**Re: Response to the NRC's Letter Dated December 20, 2018 regarding RbM  
Services, LLC, Request for Additional Information  
[CONTROL NUMBER 610517]**

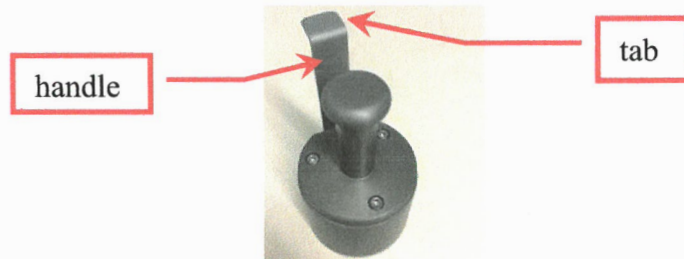
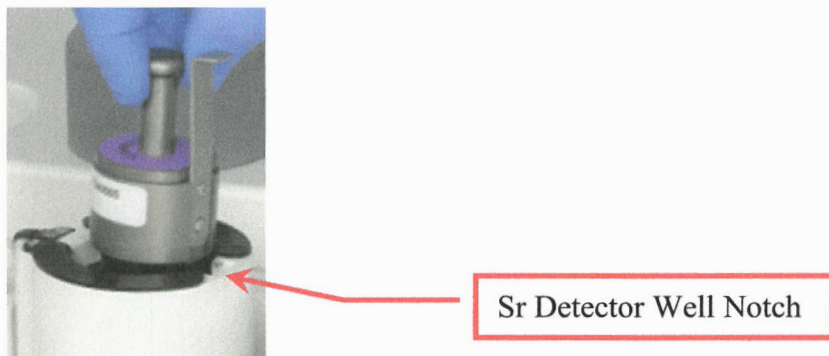
2. In order for the NRC staff to determine whether the Na-22 sources can be authorized under 10 CFR 32.18, we need to know the details of the mechanical holder that you described as "designed to provide the correct geometry."

Specifically, does this mechanical holder contain any mechanism that moves or positions the Na-22 source when the holder is inserted into the CardioGen-82 infusion system?

Stated another way, does the holder contain any parts or mechanisms that are activated by the user or by the system into which it is inserted?

The same mechanical holder is used for all of the Na-22 sources (10 $\mu$ Ci, 0.6 $\mu$ Ci, and 0.04 $\mu$ Ci). The source is placed/assembled, following a controlled manufacturing process instruction procedure, inside of the mechanical holder, which includes ensuring that the source disk seats completely flush inside the mechanical holder's base.

The mechanical holder has a handle with a tab.

The end user places the mechanical holder into the Strontium Detector Well of the CardioGen-82 infusion system and aligns the handle's tab with the positioning notch on the well.

The purpose of this alignment/positioning is so that the handle is at the top of the well and pointing upward (i.e. the Na-22 source is at the bottom of the well and not at the top) and that the mechanical holder is parallel and flush with the bottom of the well (i.e., the Na-22 source is not at an angle with the bottom of the well).

This is necessary to maintain the same geometry of the Na-22 source to the Sr/Gamma detector when this detector takes its readings.
